## National Electrical Safety Code<sup>®</sup>

### Interpretation

##### **Rule 235G Conductor Spacing: Vertical Racks (31 July 2001) IR 523**

**EXHIBIT 2**

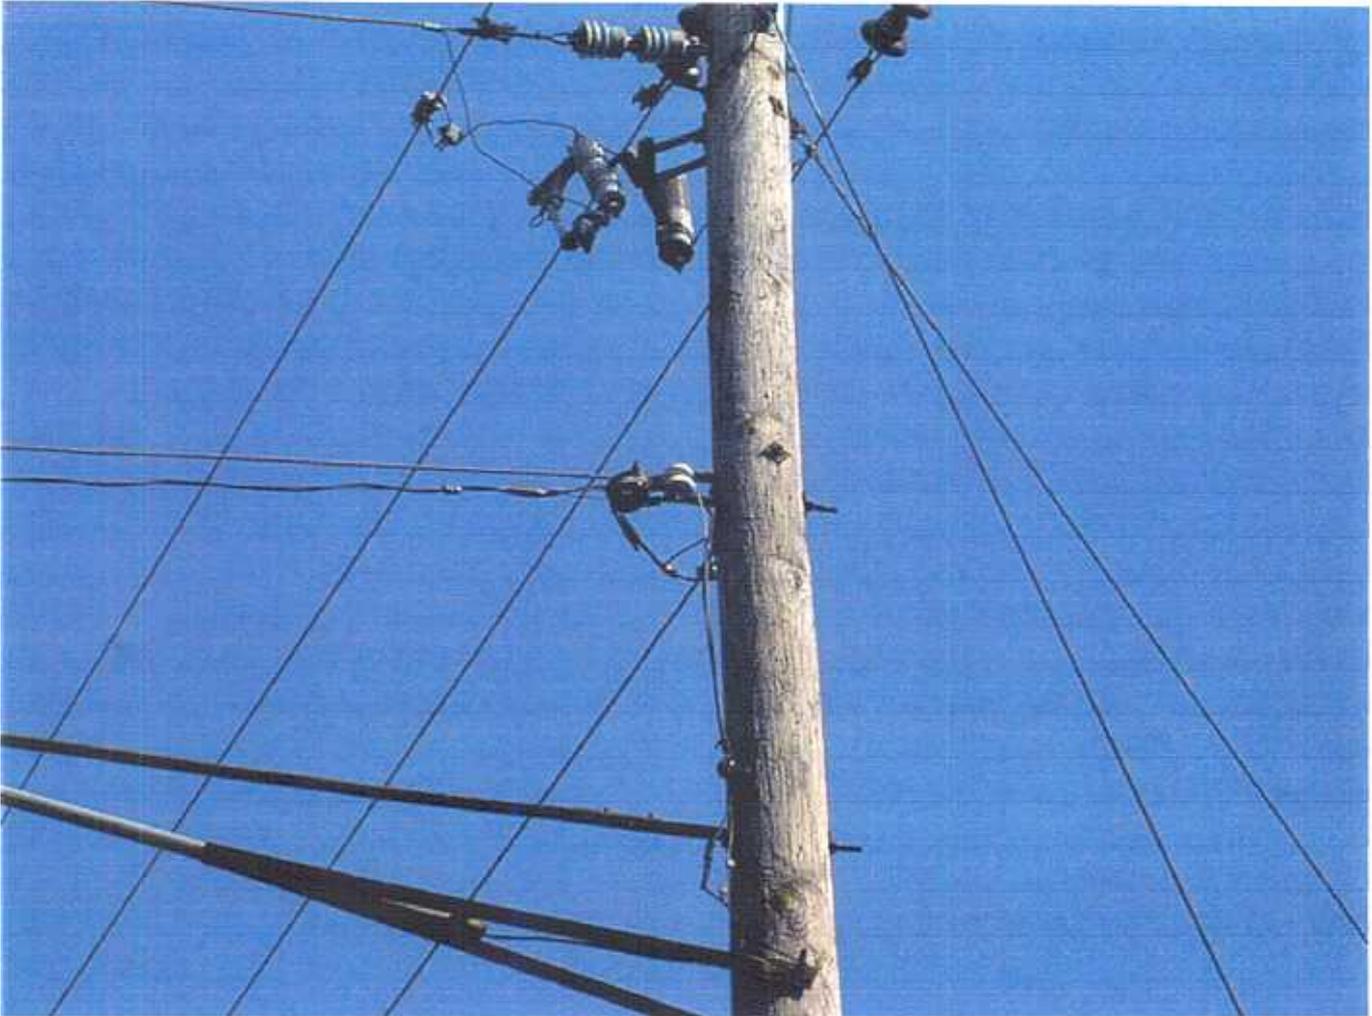
As you state in your letter, Rule 235G allows vertical spacing of 4 to 12 in for conductors or cables, dependent upon span length (and/or use of intermediate spacers). Application of this rule is limited to construction meeting the requirements of the rule and the spacing applies both at the pole and in the span. The neutral and Rule 230C3 multiplex cables shown in your Exhibit 8 drawing are line conductors; Rule 235G requires vertical spacing at the pole as well as in the span. Consequently, the construction shown does not meet NESC requirements.

**EXHIBIT 3**

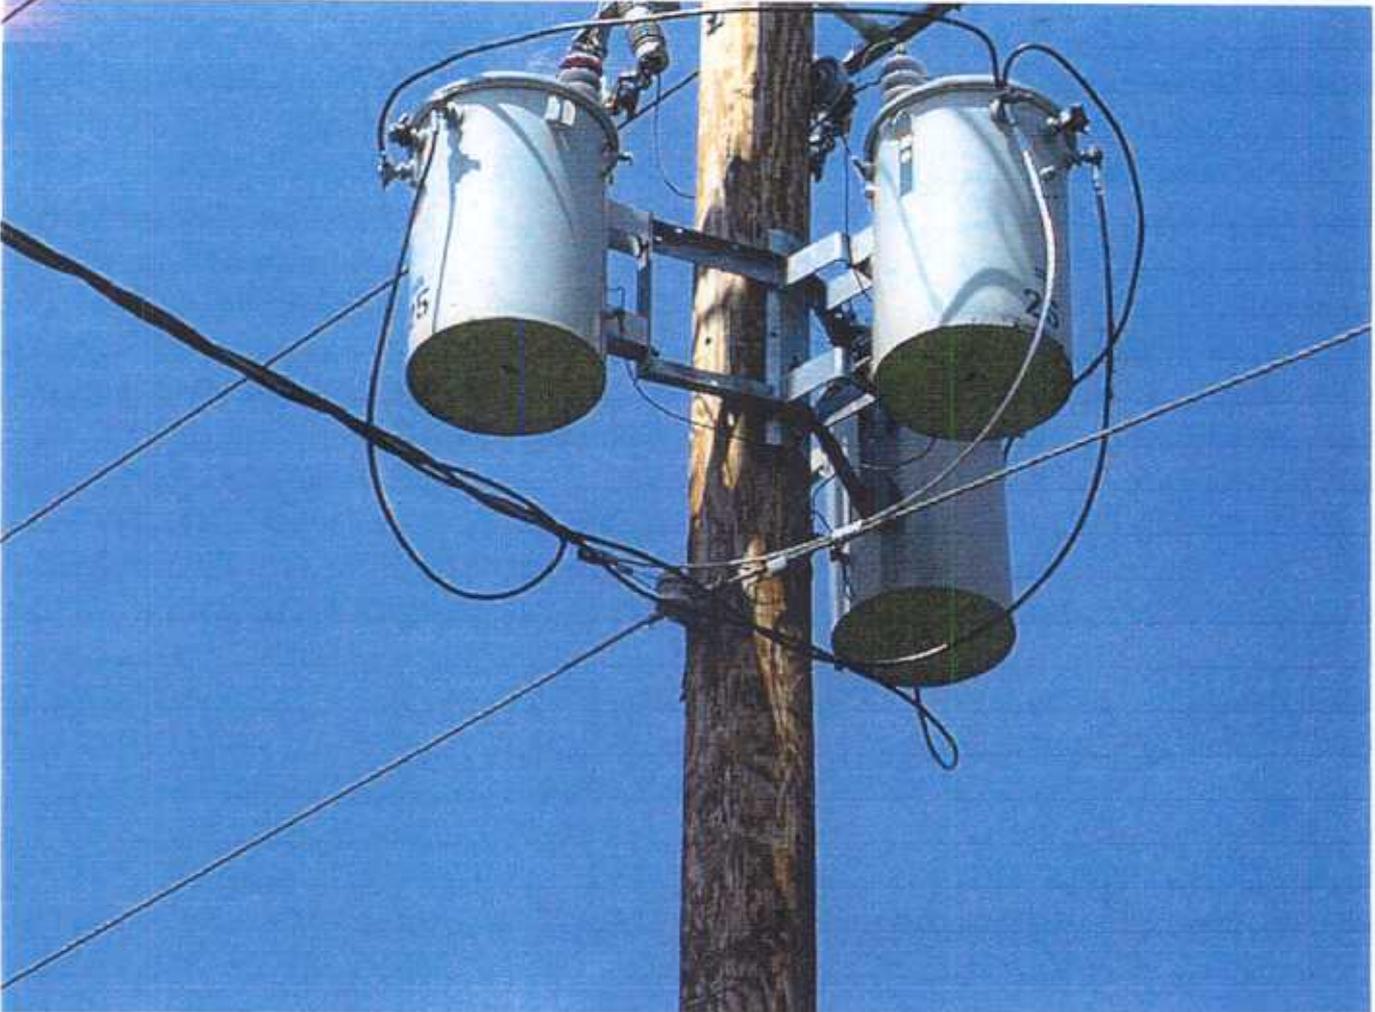
Rule 235C does not apply to non-line conductors or cables, such as service drops attached at a pole. Vertical clearance between the Rule 230C3 service drops and associated neutral conductors, as shown in your Exhibits 3–6, is not required.
